ATTACHMENT 5

Letter from M. E. Warner (NMC)

License Amendment Request 187

Revised Pages for Updated Safety Analysis Report
(USAR)

Figure 14.1.6-3

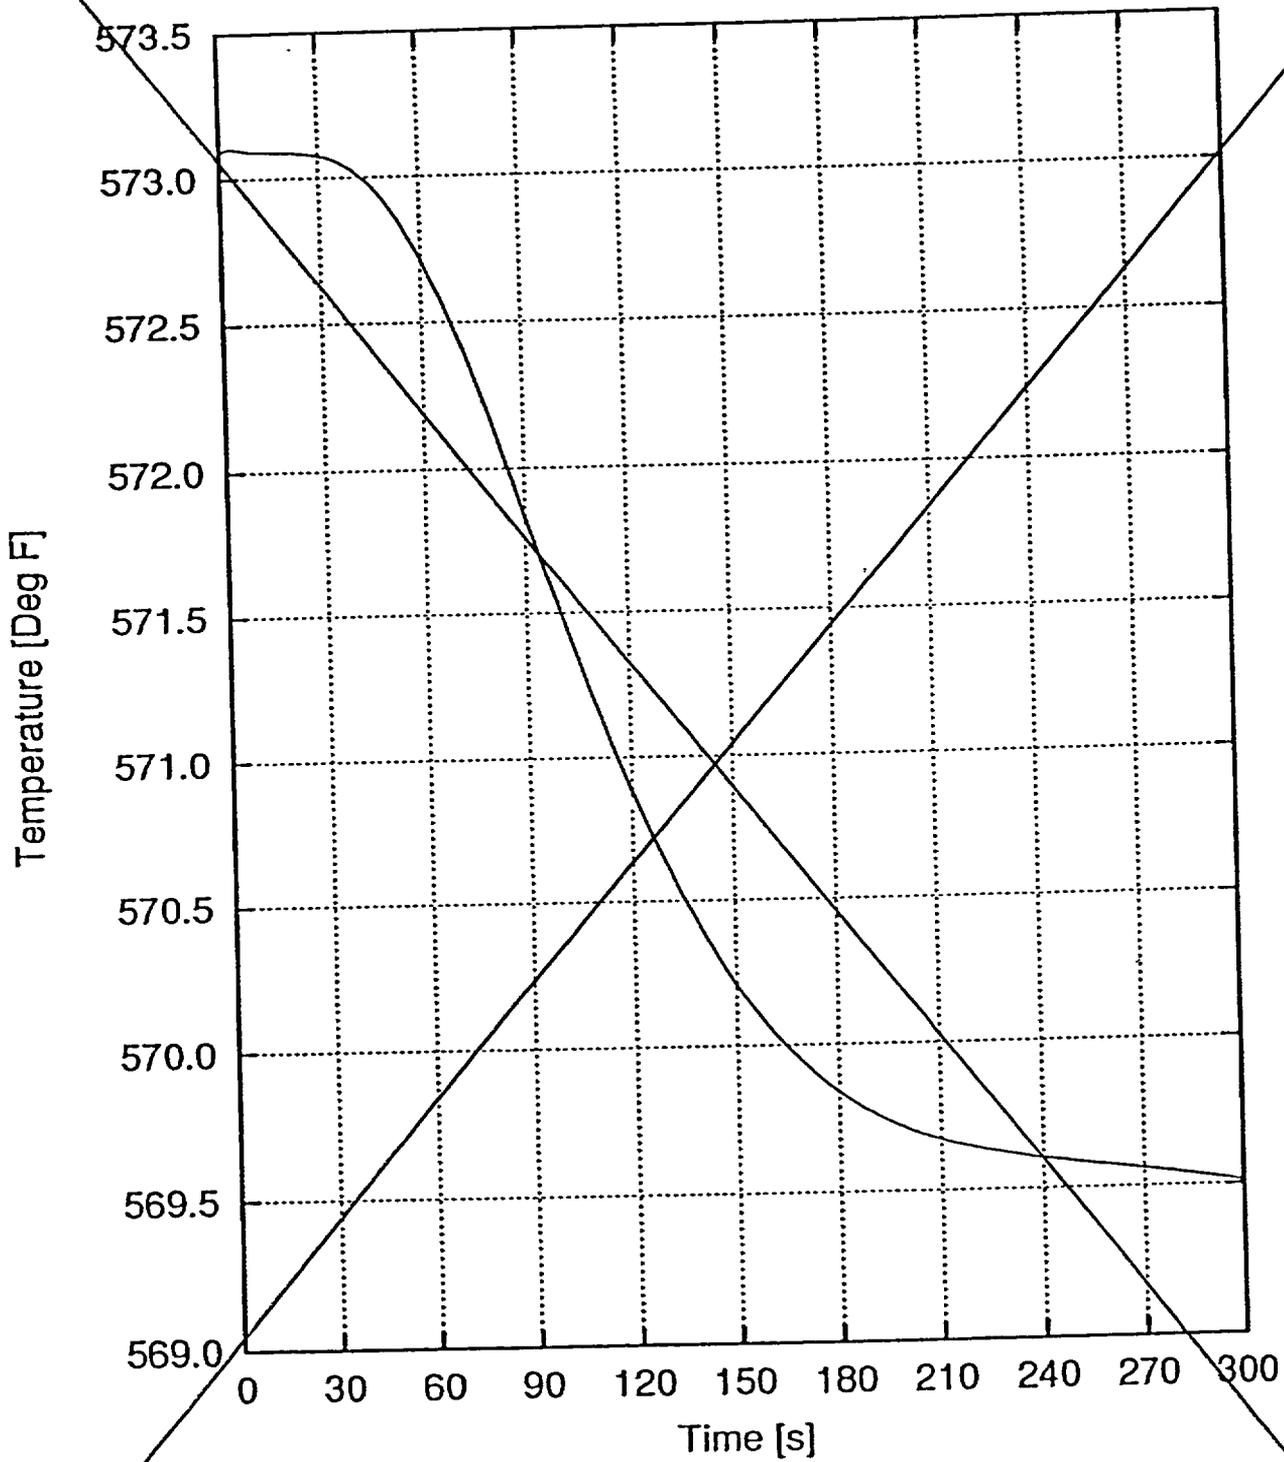
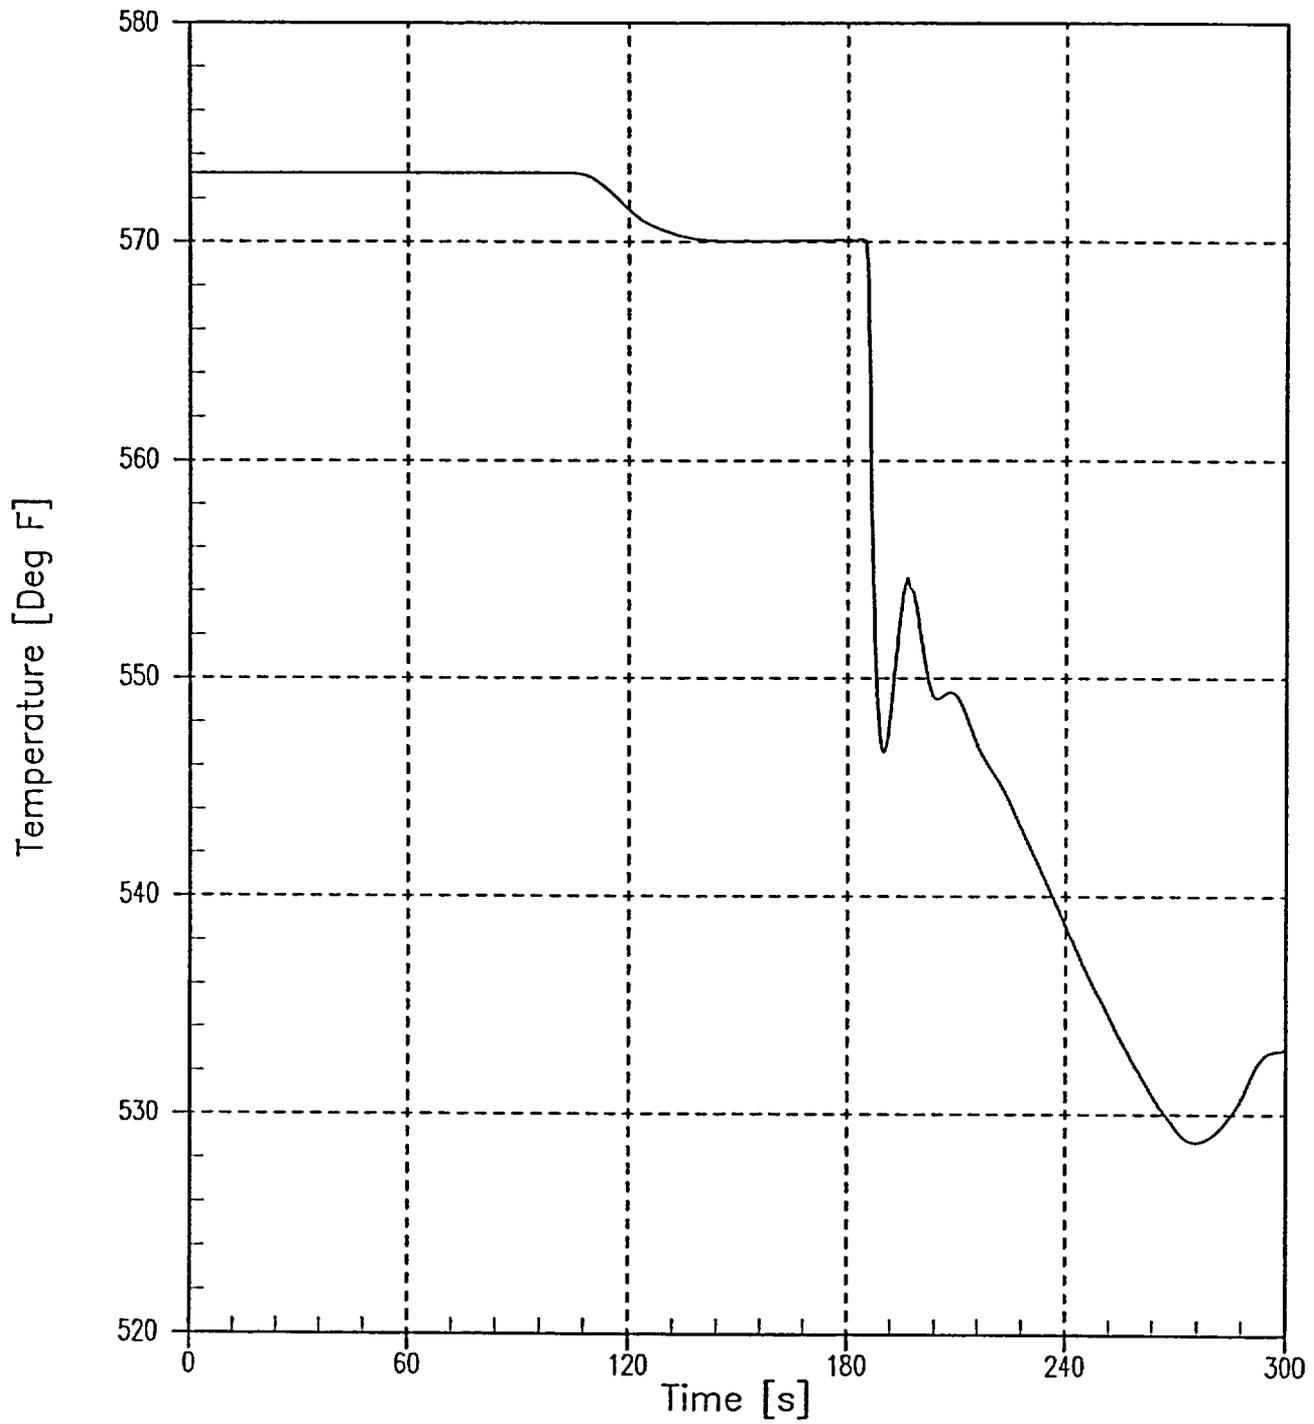
REPLACE WITH FIGURE 14.1.6-3 (ON FOLLOWING PAGE)

Figure 14.1.6-4

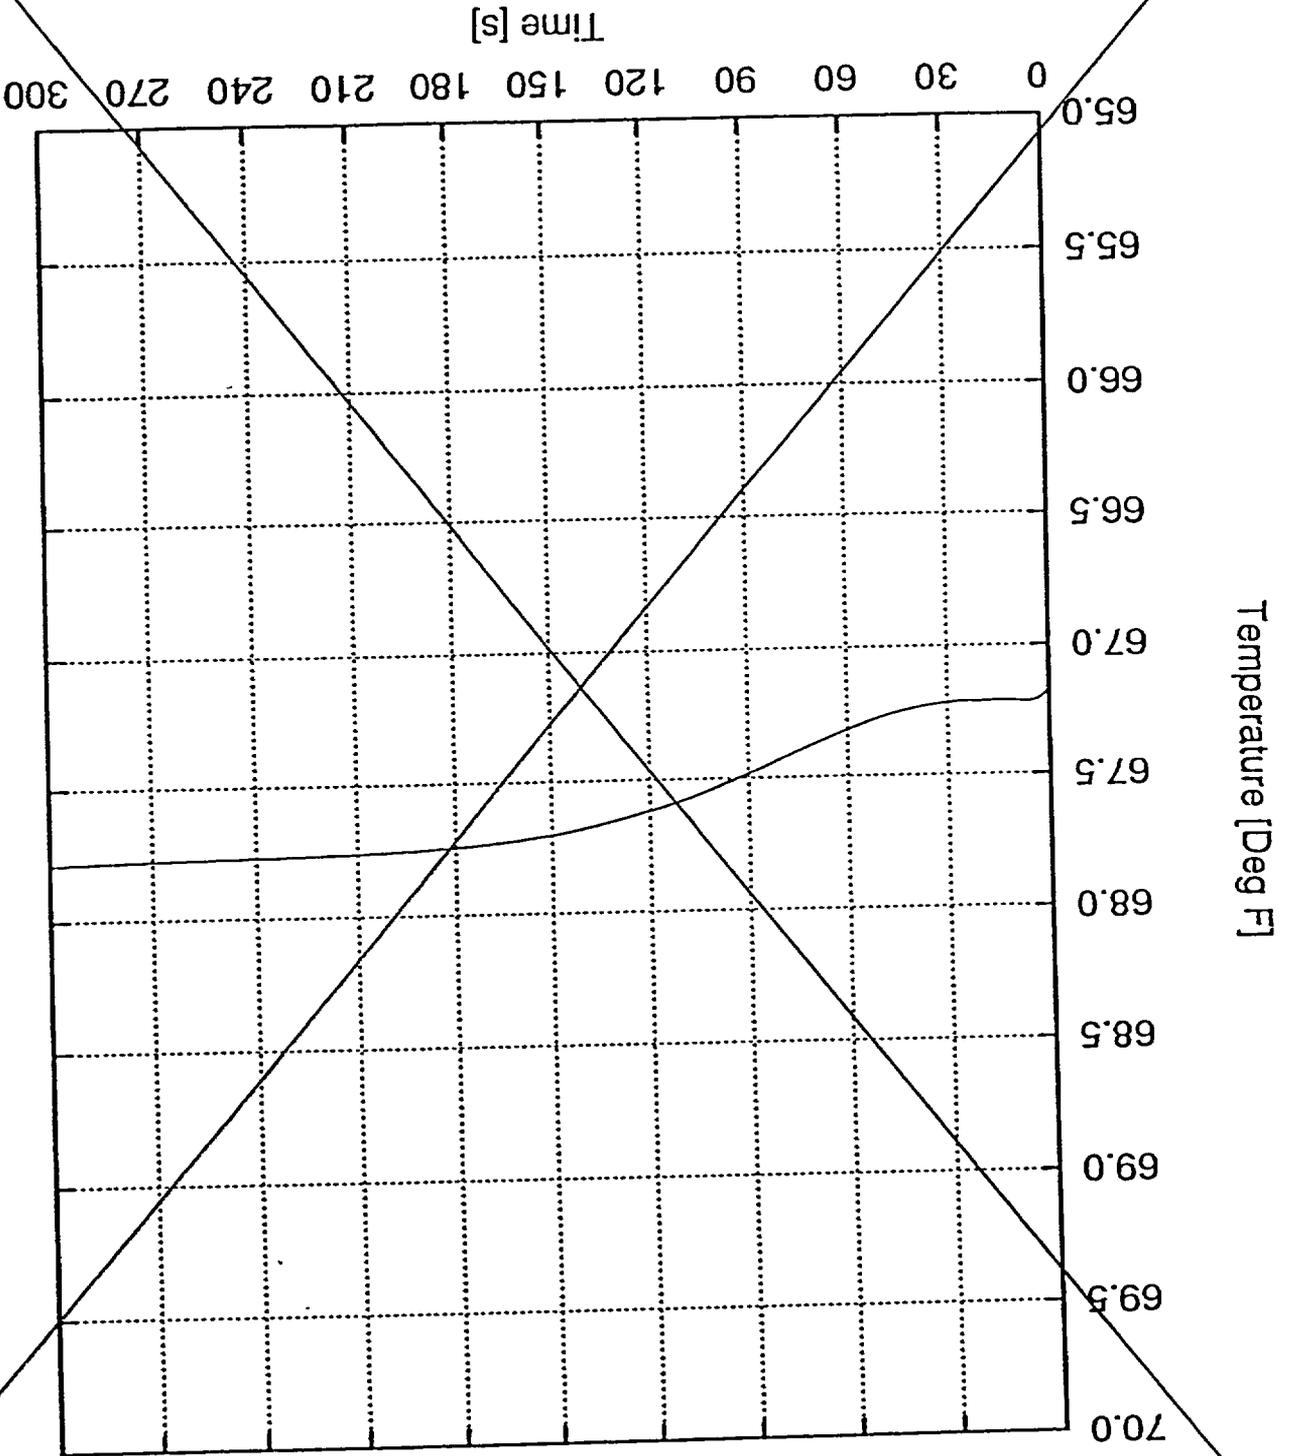
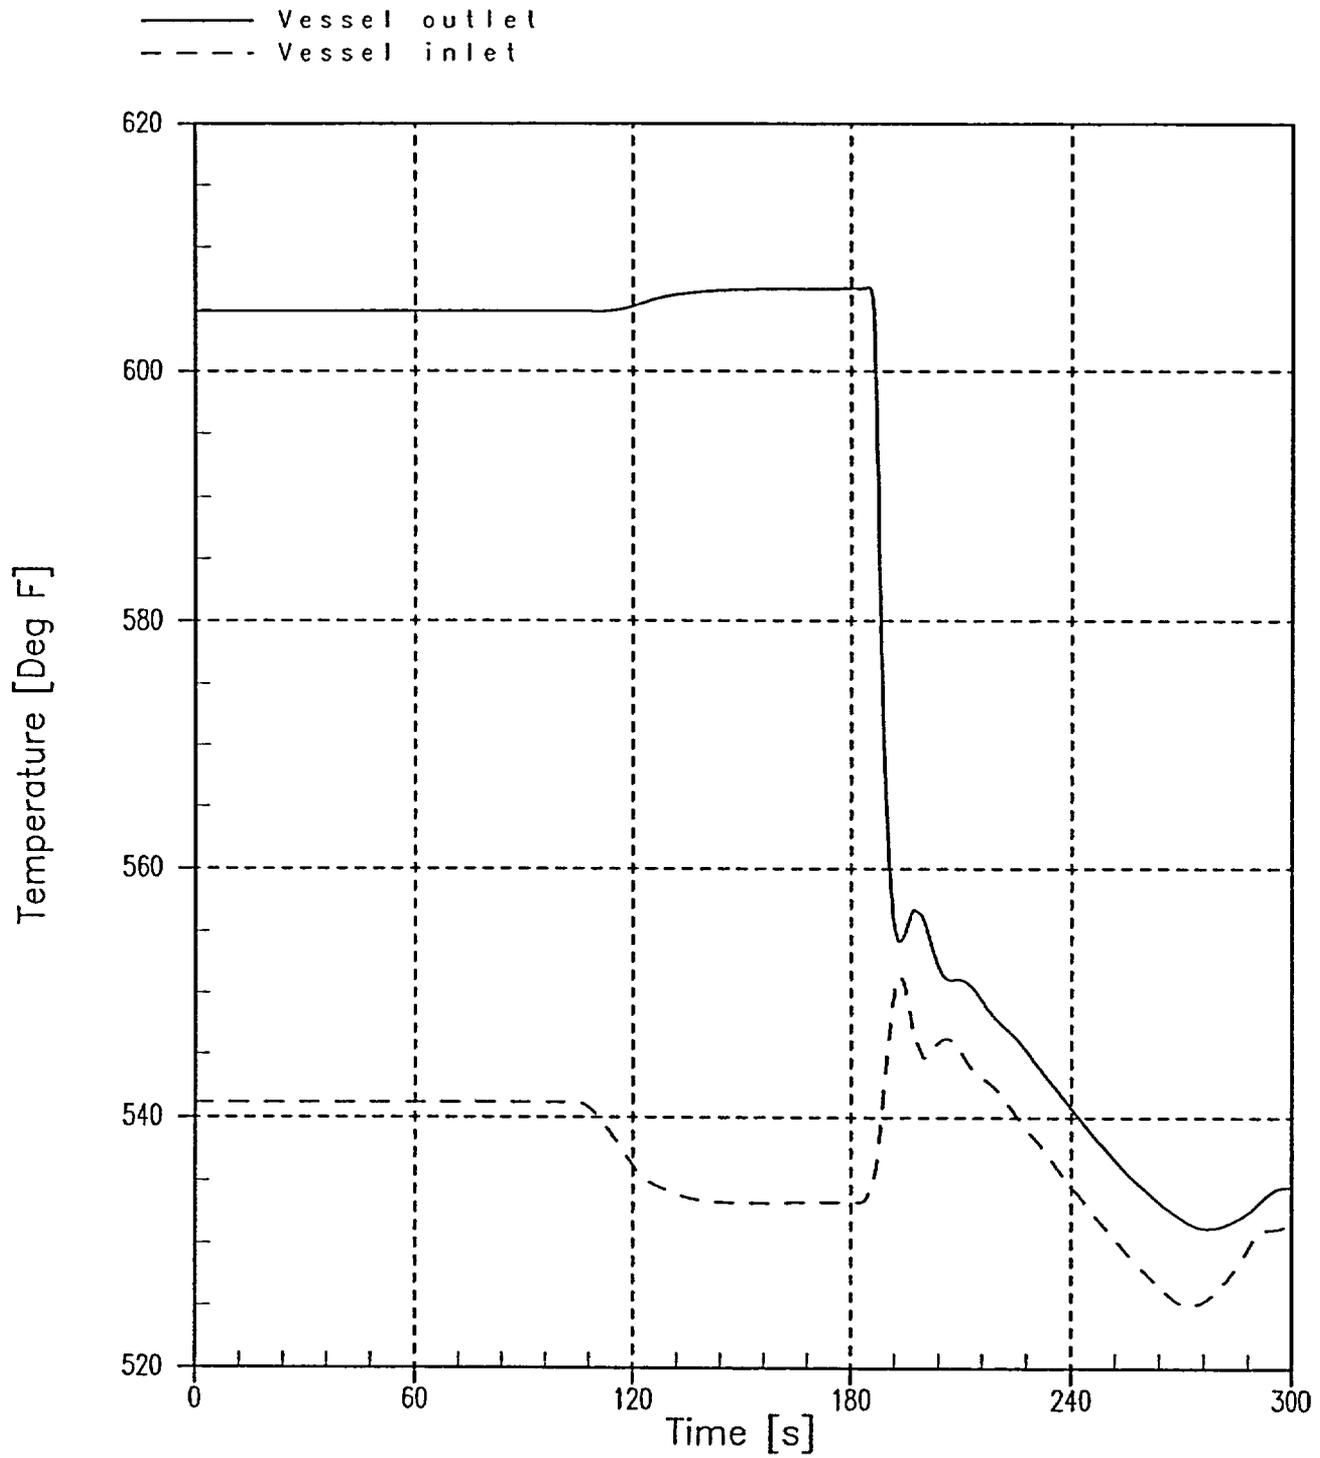
REPLACE WITH FIGURE 14.1.6-4 (on following page)

Figure 14.1.6-5

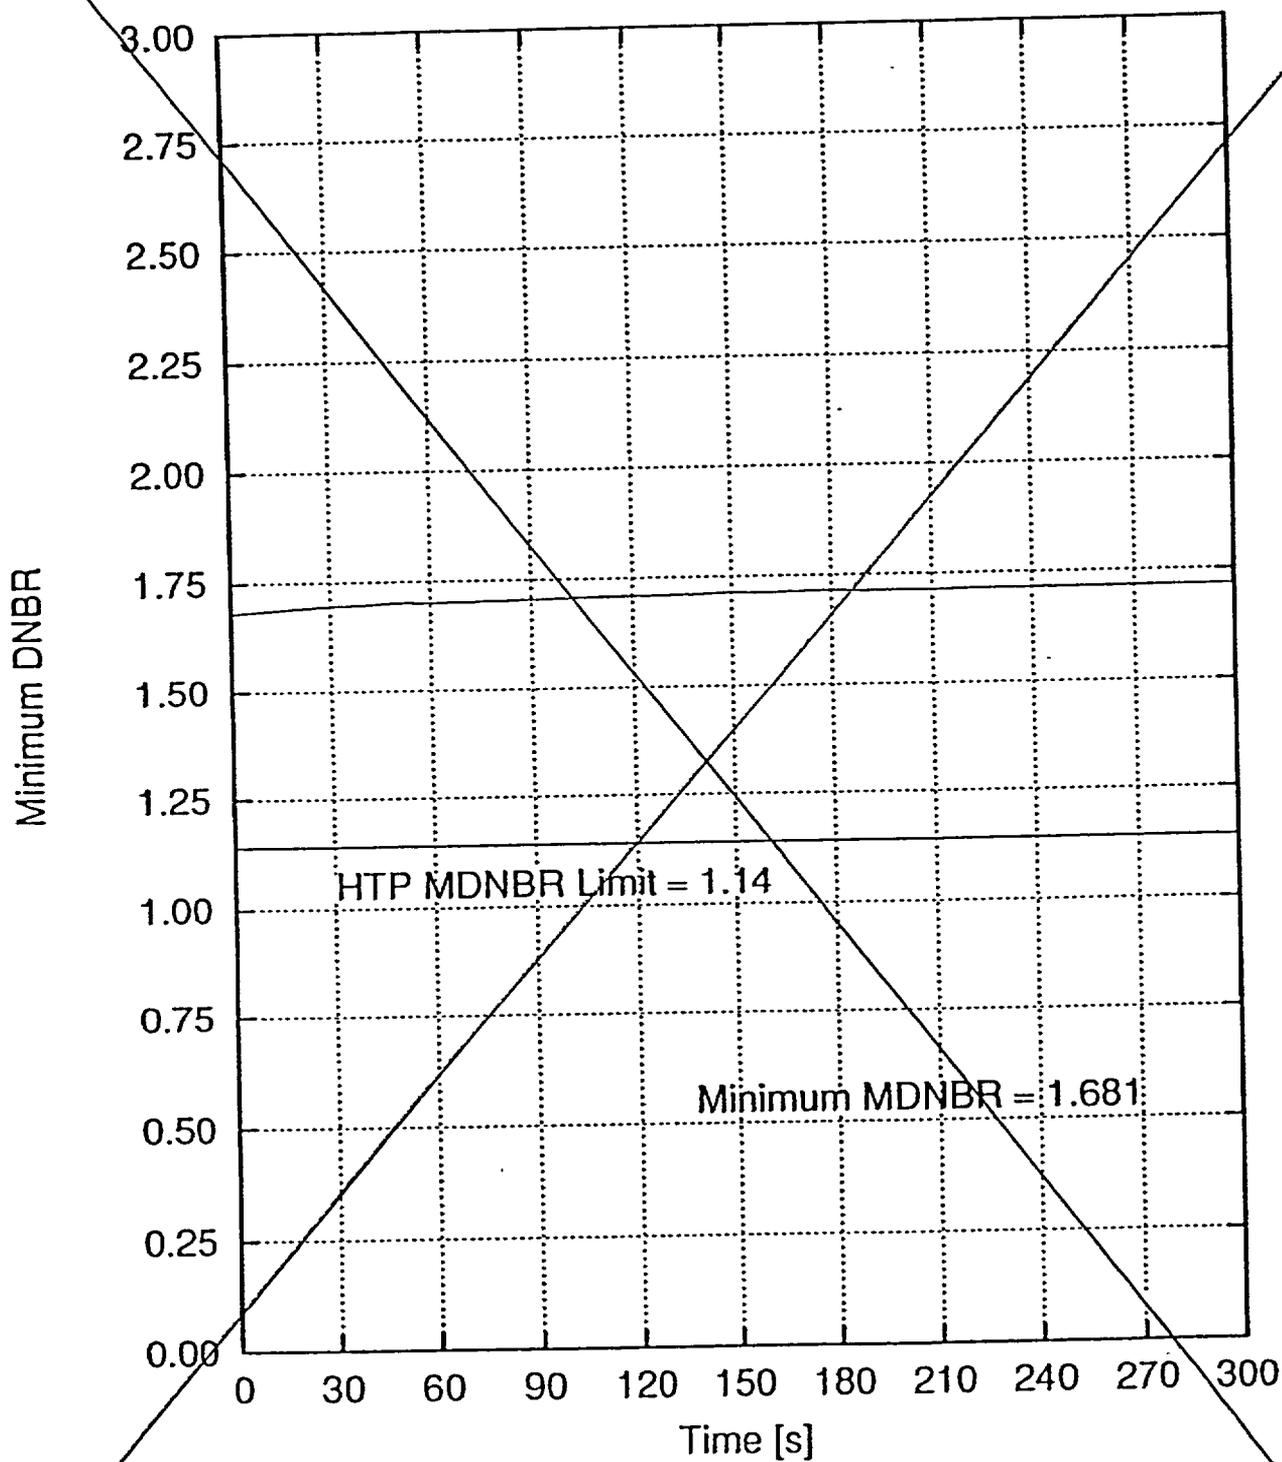
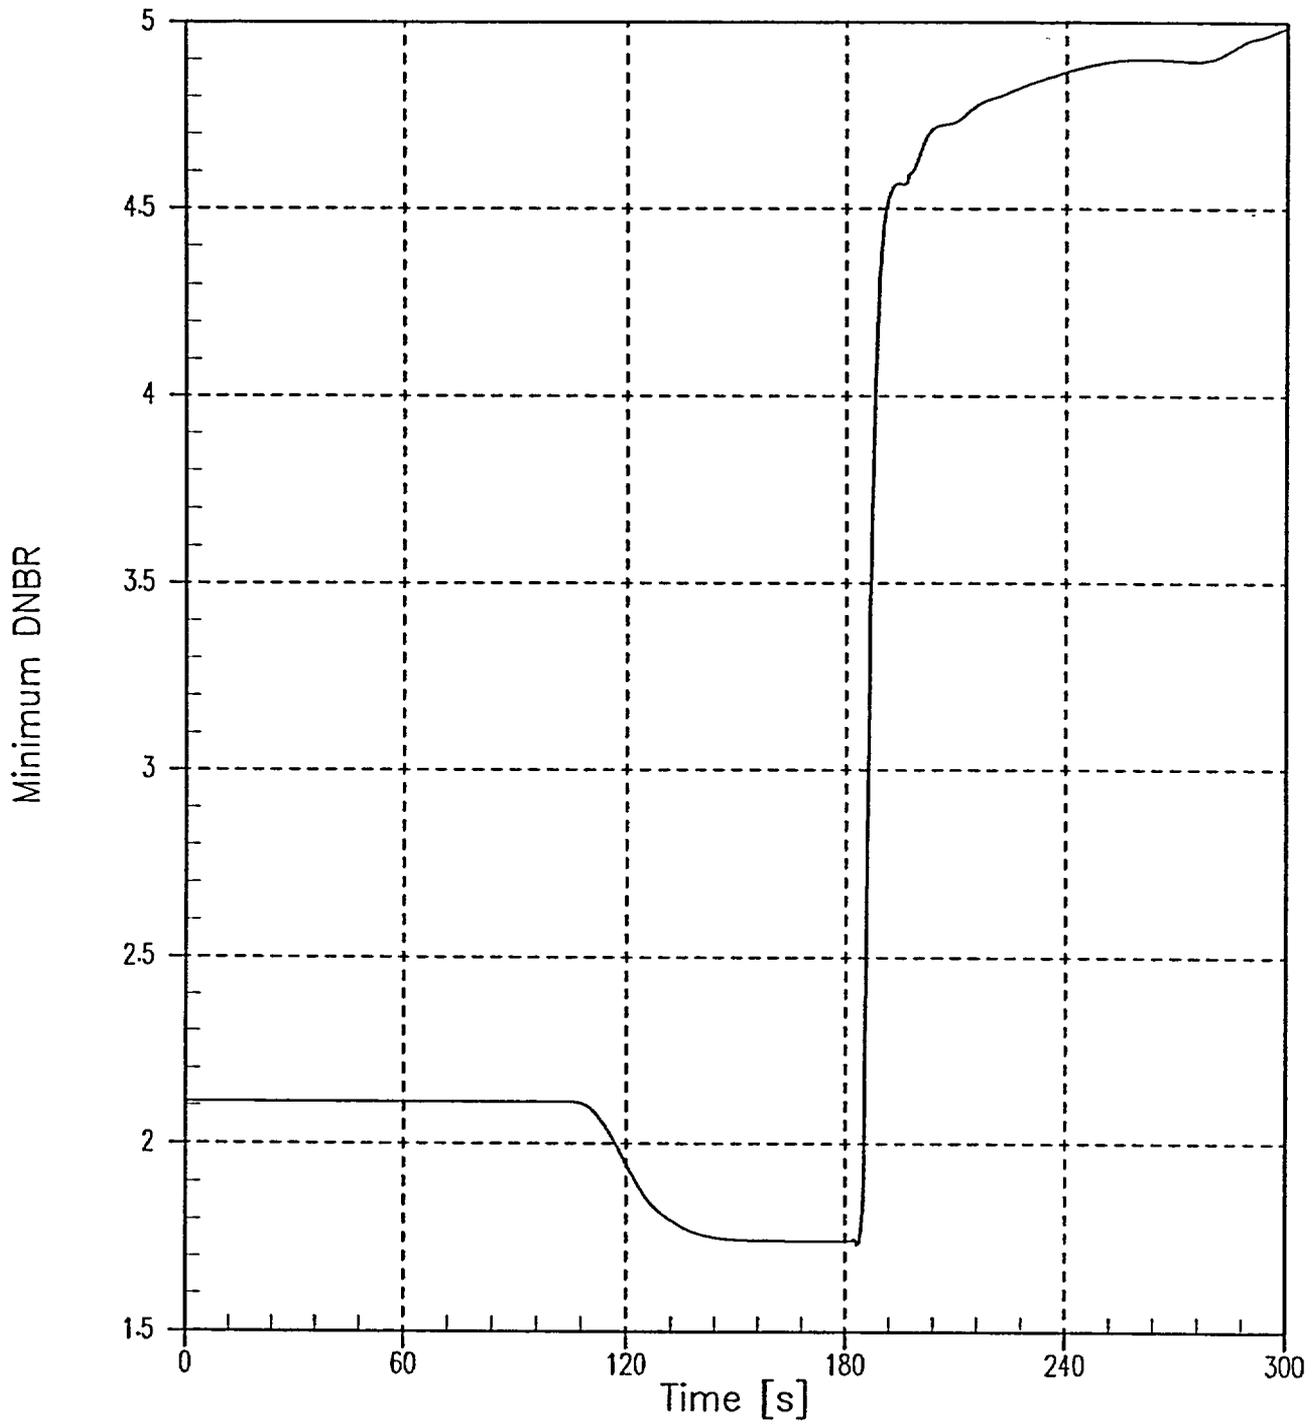
REPLACE WITH FIGURE 14.1.6-5 (ON FOLLOWING PAGE)
